To: Town of Amenia Planning Board

Memorandum

Re: MDP and Site Plan Phase 1 Comments
Silo Ridge Resort Community

Silo Ridge Ventures, LLC (the "Applicant") and its professional consultants respond to George M. Jane's October 10, 2014 comments as follows (responses are presented in the same order as the comments)¹:

Figure 1: Detail of the wall shown in C10-8 covering the eastern part of the water tank. It is approximately 12 by 100 feet and not shown on the site plans for the project, nor the visual simulations

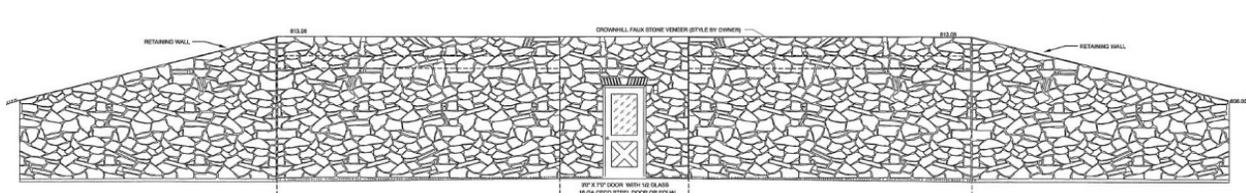
The site plan (sheet series C5) and the grading (C7) for the project do not match the plan for the water distribution system (C10.6), which shows a partially buried water tank, pump station, parking lot, circulation, and different grading, which does not match what is shown in C5 and C7. This is very serious for a number of reasons:

- The Planning Board cannot know what the applicant is actually proposing for this area as they have submitted conflicting information.
- C10.6 shows the water tank extending above grade with its eastern wall covered by a 12' by 100' retaining wall, which has a door to allow access to the tank. This is not shown on the visual simulations for the project.

The applicant must integrate the plan for the water tank and distribution system into the plans for the site, redo the visual analysis (if the tank remains visible), redo the grading, and examine that new grading's impact on the stormwater management system.

Response GMJ-1: The water storage tank and all related infrastructure has been relocated south of Route 44 and west of the driving range. The water tank will be partially buried with the exposed side facing the woods towards the west, which will therefore not be visible from any vantage point or public roads. Please refer to the following:

Figure 2: Detail of SP-04 from the MDP plans. Areas that are counted as open space, but which are not open space are marked

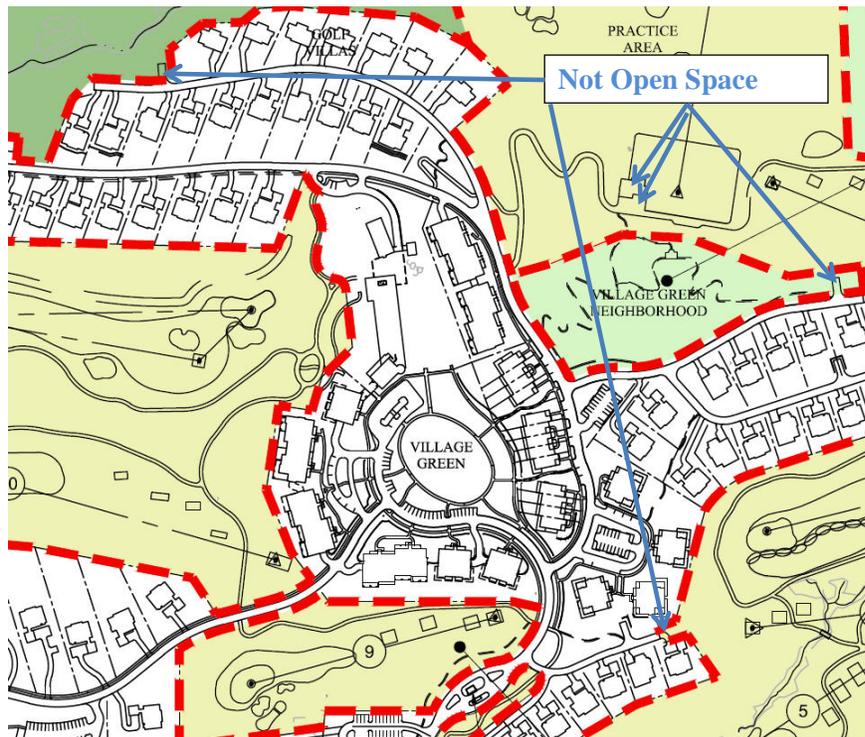
Open space for the project shown on SP-4 of the MDP plans exceeds the 80% open space requirement by slightly over 1 acre. This calculation, however, includes some space that according to the Town's zoning should not be counted as open space.

The partially buried water tank, the pump station, and the related non-recreational paths and staircases used to service this infrastructure in the hairpin turn, are counted as open space, which clearly do not fit the definition that is in the definition of open space in the zoning code. Further, the golf academy building cannot be considered open space as it is a non-residential building over 200 SF. The impervious golf cart parking area around the golf academy and road hammerheads cannot be counted as open space. The following image identifies some of these smaller spaces counted as open space that should not be counted as open space:

Response GMJ-2.a.: There is no rational basis for distinguishing ancillary golf cart staging areas from cart paths for purposes of Section 121-18C(4) of the Zoning Code. The golf academy building and all other buildings larger than 200 square feet have been removed from the open space calculations, including the water storage tank and pump station – please refer to MDP Drawing SP-4. Please note

that the water storage tank and all related infrastructure has been relocated south of Route 44 and west of the driving range. All road hammerheads have been removed from the open space calculation.

Figure 4: Detail of C7-08 showing the area being graded in yellow, with the implied height of some of the retaining walls called out

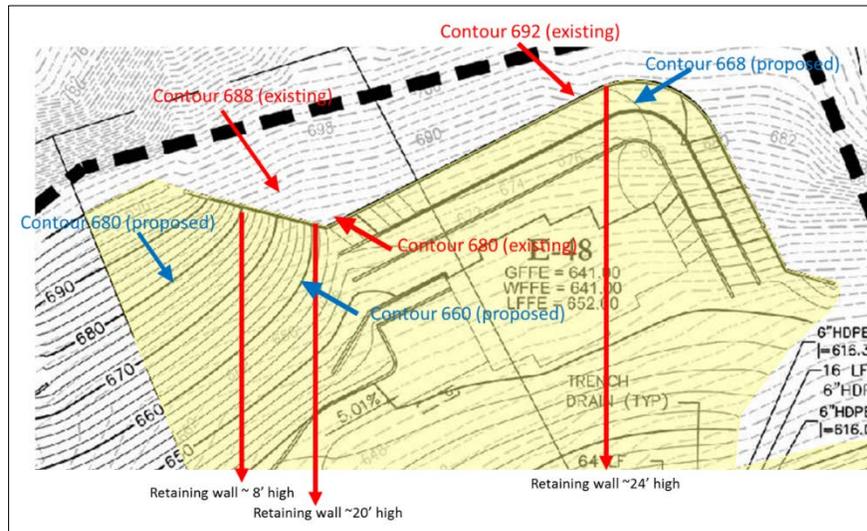
The project calls for some very tall retaining walls. I believe that many of the taller walls will need a railing of some kind for safety purposes and these railings are not shown on the site plans. Railings would need to be shown on plans. But more than this minor omission, the Planning Board should consider if these very tall walls should exist at all. For instance, examine the following detail from Lot E-48:

The implied height of the tallest retaining wall on this lot is measured in several places in the image above, and shows the wall is about 24 to 25 feet tall at its tallest. This very tall wall is the last of three stacked retaining walls, which together cover about 40 feet in vertical elevation, which is taller than the proposed house.

Response GMJ-4.a.: Please refer to Response JSM-1.2 regarding retaining walls.

Figure 5: Section through a house designed for development on steep upslope

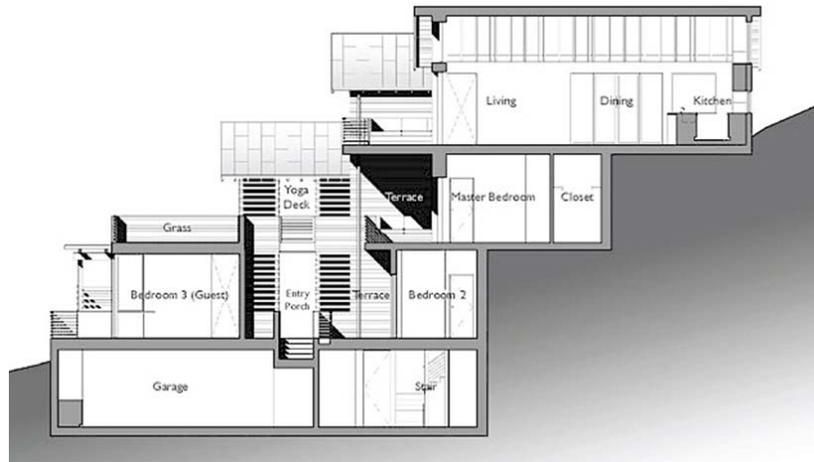
two or three floors into the hillside and allow for a sloping rear yard. The following is a section of a house that is designed for a steep hillside:³

- Encourage the applicant to consider more compact design that would allow difficult sites like E-48, which requires 40 vertical feet and 850 linear feet of retaining wall, to be left unbuilt.

Response GMJ-4.b.: Please refer to Response JSM-1.2 regarding retaining walls and Response MWK-3 which shows the decrease in total site disturbance, including disturbances to steep slopes, when comparing the current approved October 2009 master development plan to the Amended MDP. Disturbance to naturally forested slopes is decreased by approximately 13.7± acres, and to all steep slopes (including naturally forested slopes) by more than 25 acres. The Amended MDP is therefore a "more sensitive design" than the approved October 2009 MDP. The Applicant has throughout the course of the review process "[refined] the design so as to further minimize impacts to steep slopes".

The Applicant agrees that a tier-style house is appropriate for these conditions, and will encourage that style when each Estate Home buyer is custom designing his/her home. However, for impact review

purposes, the drawings assume the "worst case scenario" of a home having only one story that catches grade. Please refer to Site Plan Drawings C6.08, C6.09, and C6.11.

Figure 6: Detail of C3-08 on the left with the same area of C7-08 on the right. The circled area shows an area that will be developed where the tree survey did not cover. There is mature forest in the circled area.

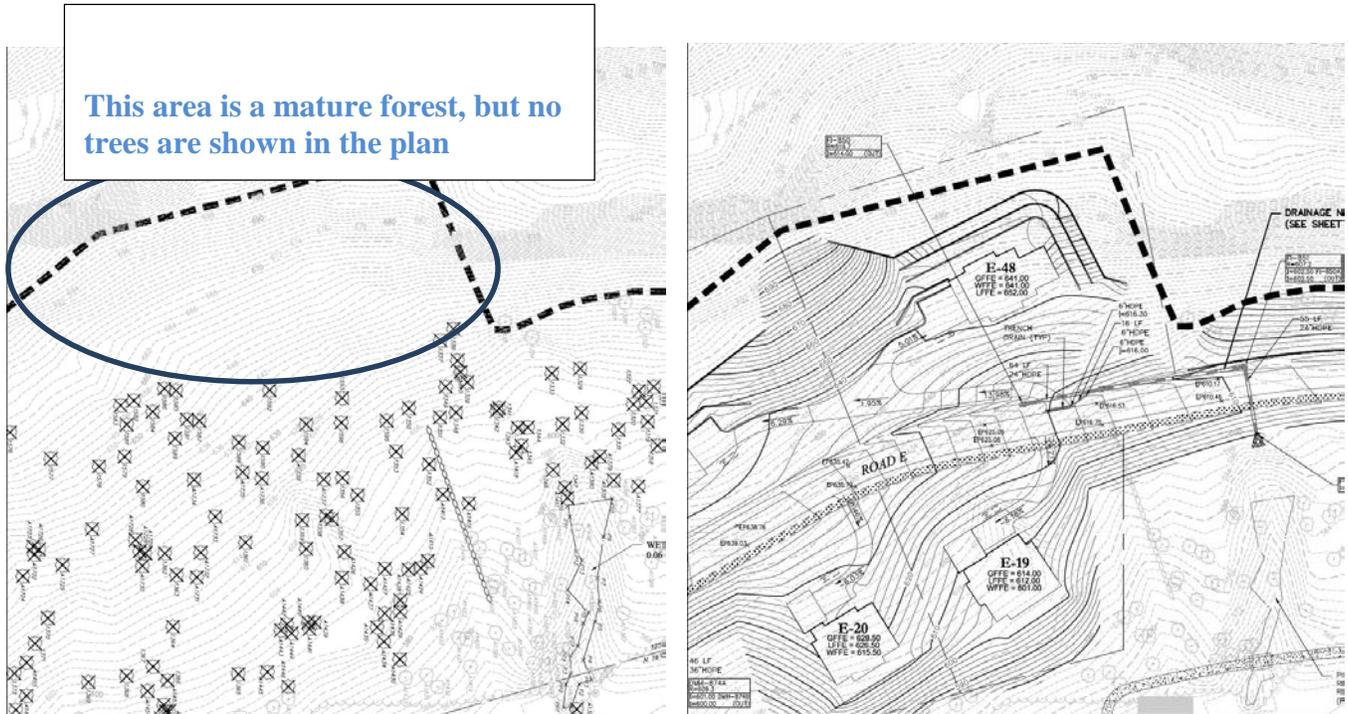
The boundary for the tree survey ends before the development does. The result is that heavily forested areas on the demolition survey are shown as if they have no trees or tree removal. For instance, consider the following details for the area around E-48:

The image on the left shows the demolition plan for the existing trees on the site. The image on the right shows the grading plan and the houses for the same area. Mature forests cover the area where E-48 is planned, yet the tree survey shows that there are no trees beyond what would be the front yard. There are trees on this site and many of them will be cut. It appears that the tree survey also falls short in lots E-49, E-50, E-51, and E-53. The applicant must complete the tree survey.

Response GMJ-5.a.: Additional tree surveying has been performed along the southern end of the Estate Homes area and portions of the South Lawn neighborhood. The additional survey performed in the Estate Homes area only encompasses the ADA areas and other areas of potential disturbance (i.e. roads). The additional information is included on the revised existing conditions and demolition plans – please refer to Site Plan Drawings C2.05, C2.09, C2.11, C3.05, C3.09, and C3.11.

Figure 7: Detail of C3-06 on the left, with a detail of the same area on C7-06. Every tree within the limit of work on the Estate Home lots is cleared, regardless if the area is being graded

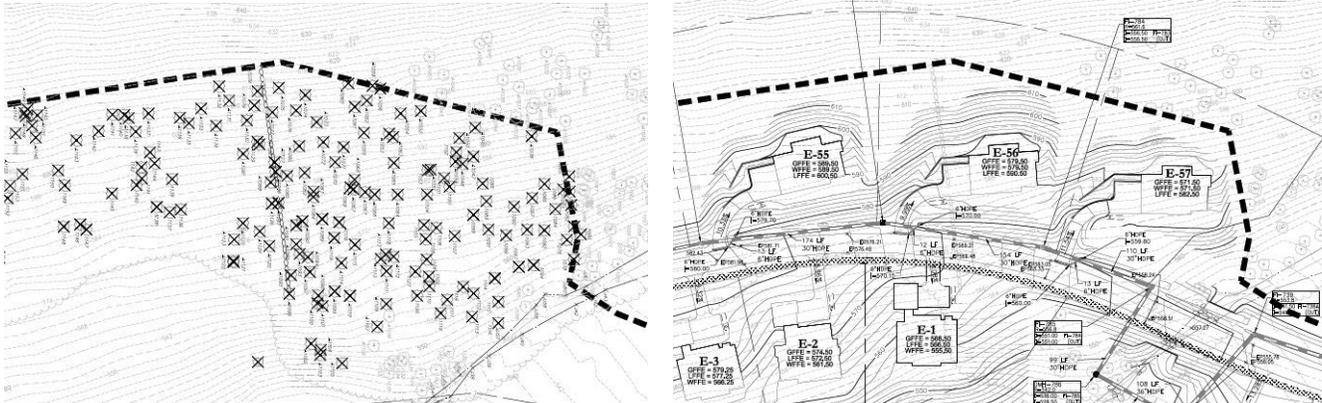
The demolition plan on the left shows every tree on the up-slope Estate Home lots within the limit of work will be cleared, regardless of the need to grade the area. Many of the trees in areas that are not graded could be saved and according to the Findings and zoning, they should be saved.⁴ The Findings Statement states: "Cutting of existing vegetation will be minimized by field surveying each building site including trees 8" caliper and larger prior to site plan submission *and custom designing each building for the site.*" [Emphasis added.]

The Planning Board should ask the applicant to examine every lot and tree and work to minimize the footprint, area of disturbance and leave trees undisturbed if building or grading does not require removal.

Response GMJ-5.b.: All plans have been revised to show clearing on Estate Home lots only within the designated "allowable disturbance area" ("ADA"), and on certain lots, the delineated "driveway envelope" and "sewer envelope". The Design Standards for Estate Homes addresses clearing of existing vegetation, as well as what landscaping will be required in order to minimize impact on naturally forested areas, as thoroughly discussed with the Planning Board and its consultants.

Figure 8: Detail of L3-02 showing the thick landscaped screen planned for the lower portion of Route 44. The red "1" marks an area of existing forest that could be narrowed to allow for better views

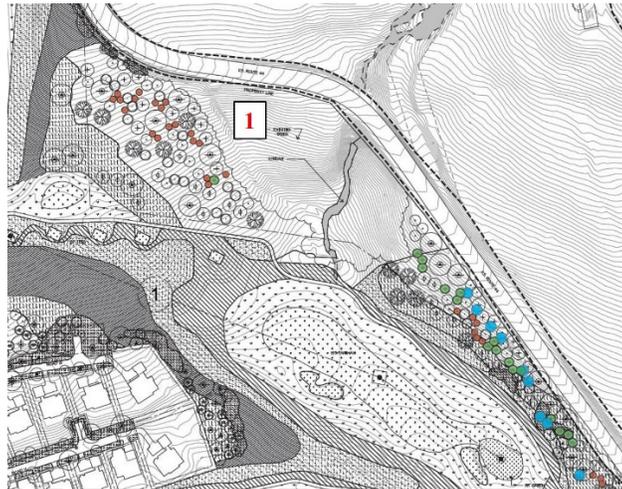
The Planning Board should consider requiring changes to the landscaping plan to preserve the views along DeLaVergne Hill. Currently, the plan calls for a thick vegetative buffer along much of Lake Amenia Road and Route 44 at the north end of the site. This buffer primarily screens the public view of the golf course. The golf course is a part of the 80% open space requirement of the RDO; as such it should be considered an attractive element and views to it should be enhanced, not blocked. As currently proposed, landscaping at the project edge will remove public views of this preserved open space. For instance, consider the following detail from L-3.02:⁷

places.” [Emphasis added.] Partial removal of this stand of trees, along with a visually sensitive green buffer will help to open up these important public views.

Response GMJ-8: At the Planning Board’s request, the Applicant has eliminated the hedge and fence along the hairpin turn on Route 44.

The Planning Board has advised the Applicant that existing trees along the lower section of Route 44 do not need to be removed. However, as additional mitigation for potential visual impacts, the Applicant has committed to working with the Planning Board and NYSDOT to remove existing trees at the hairpin curve, to maximize views from DeLaVergne Hill and the Artisan’s Park Overlook. The existing conditions plans and demolition plans have been revised to show the existing trees around the hairpin turn and identify them for removal – please refer to Site Plan Drawings C2.02 and C3.02. The NYSDOT Roadway Improvement Plans (RIP) also identify these trees to be removed – please refer to RIP Drawings GP-6A and GP-6B.

Figure 10: Detail of L3-02 showing part of the edge of the Village Green neighborhood

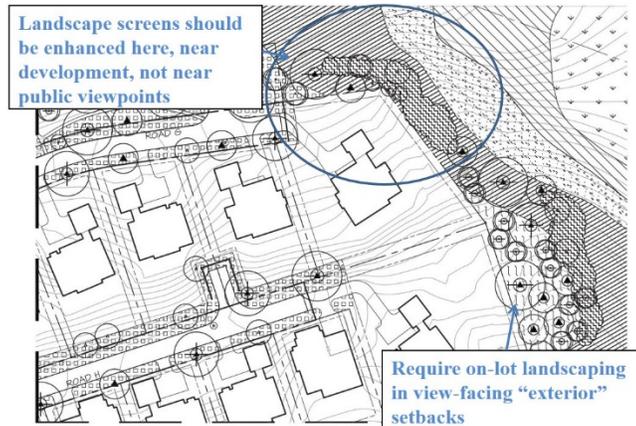
soften the effect of development on the landscape. For example consider the following detail of L3-02, which shows the outer edge of the houses planned for the Village Green neighborhood:

In places at the edge of the development, like the portion circled above, the proposed landscaping thins. The landscape screens currently proposed for lower portion of Route 44 belong in locations like this. In some places the distance between the lot and the golf course is not large, but the planted area could be expanded if vegetative screens are required in all exterior⁹ setbacks. Enhanced landscaping closer to the development and further away from the viewer will keep the views expansive, and in most cases, at a much lower elevation.

This landscape screen can be designed to screen distant views, but could also be designed to allow views out from the homes to the golf course. Such a design would likely include trees with substantial canopies that would screen views to the houses from distant viewpoints, but with the lower limbs trimmed to allow ground level views outward.

The landscape plans have been revised to show native shrub groupings downslope on the golf side providing additional screening of the Village Green neighborhood homes – please refer to Site Plan Drawing L3.02. Additionally, it should be noted that each lot has minimum landscaping requirements. Typical lot landscape plans are show in Section 1.4 of the Amended MDP and are shown on MDP Plan Drawing SP-9. In addition, the landscaping restrictions for the 103 single family homes (Village Green

Figure 12: Aerial view of the Hamlet of Amenia, with the proposed Waste Water Treatment tanks shown. The red line is a 500 foot buffer around those tanks

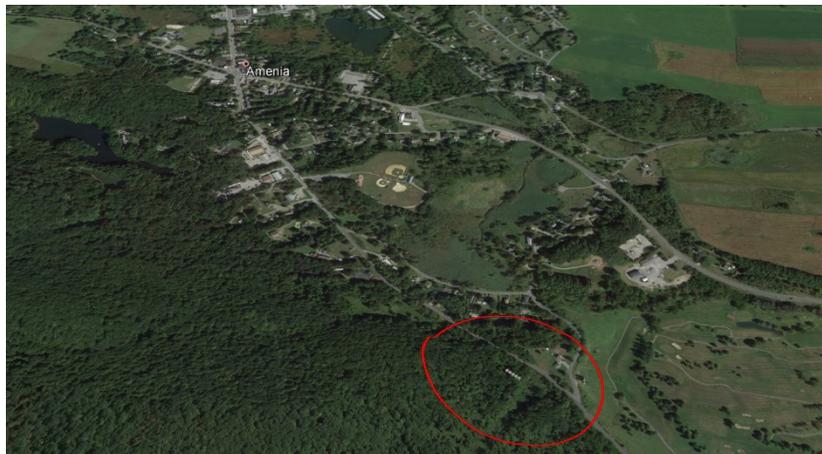
But is this a reasonable location for the WWTP at all? The following aerial photograph showing the tanks proposed for the WWTP with a 500 foot radius around the tanks shown in red:

Is it reasonable to site a WWTP so close to residences on Lake Amenia Road? Is it reasonable to site a WWTP that will not be used by the Hamlet of Amenia so close to the Hamlet of Amenia? This location was selected, in part, because it was thought that proximity was important in the logistics required to hook a future hamlet wastewater system into this facility. But since the Town is no longer planning on using this facility, the Planning Board may wish to ask the applicant to consider moving the WWTP to another location entirely. Not only does the facility as planned violate NYSDEC

guidance as to siting,¹⁰ it is very close to the Hamlet of Amenia, and the Planning Board can fairly ask if such a facility sited contrary to DEC guidelines is appropriate for this location. The applicant has already sited the golf maintenance facility off-site, so perhaps alternate locations for the WWTP could be developed as well.

Response GMJ-10: Please refer to Responses GMJ-3, GMJ-6.a. and JSM-1.21.

Figure 13: Detail from SL1.06 showing up-lit spotlights

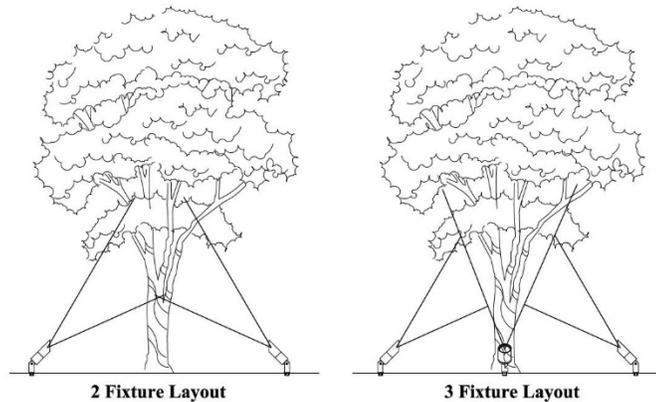
It appears that the lighting plan for the project does not consider the conditions of the Findings Statement, especially as it regards up-lighting. The following lists conditions of the Findings and a portion of the lighting plan that violates those conditions.

Response GMJ-12.a.: All uplighting (previously shown in pool areas and for trees as part of landscape lighting) has been eliminated. All fixtures now comply with current requirements. Please refer to Site Plan Drawings SL-1.00 to SL1.09 for lighting design.

Figure 15: MDP SP4 draped on Google Earth elevation model of the town, to demonstrate the issue with changing elevation in 3D

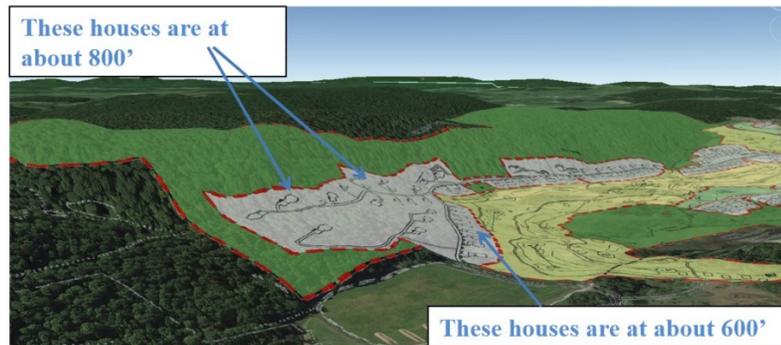
The following image drapes the plan for the area on the Google Earth elevation model for the town, and is designed to illustrate the topography in this area in 3D:

The houses that line the golf course are at about elevation 600 feet. The houses at the highest portion of the development are at about elevation 800 feet. The changing elevation means that houses cannot be used to hide each other and appear to climb up the hillside as seen in photo simulation:

Response GMJ-13.a.: The south end of the Estate Home neighborhood has been redesigned and is now included as part of Phase 1 of the Modified Project.
